FLOOD RISK RELATED COMMENTS ON DEADLINE 2 SUBMISSIONS IN RESPECT OF SCOTTISH POWER RENEWABLES EA1N AND EA2 PROJECT ONSHORE WORKS NEAR FRISTON For

SASES

December 2020

Job: SASESFRA
Report Number: 201217
Version: v.02
Issue Status: Final

Friston – location map of photographs taken on 5 December 2020 after heavy rain

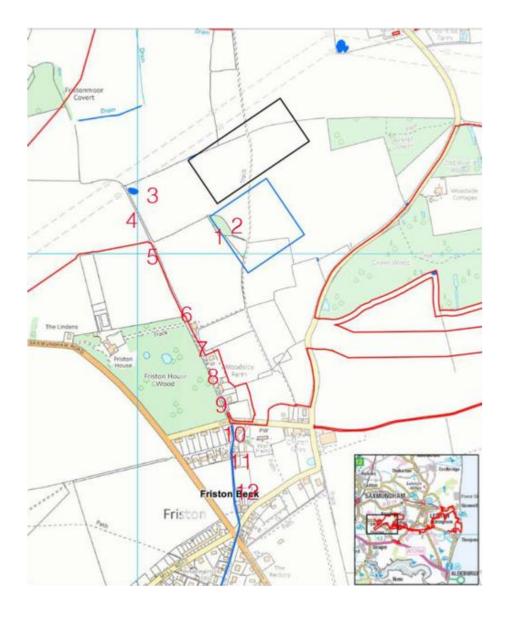
A recent rainfall event in Friston village occurred on 4-5 December 2020. Photographs taken by local residents show the temporary ponding of water within depressions on the proposed site area, as well as overland flows down into the village and through the village.

Whilst not described as a flood event, this relatively small rainfall event confirms the current vulnerability of Friston village to overland flows after intense rainfall, with clear evidence of limited ditch conveyance capacity, proximity of current overland flows to residential properties, retention of field drainage within depressions (one or more of which will be infilled by the development), and the turbid quality of the run-off within the upper watershed.
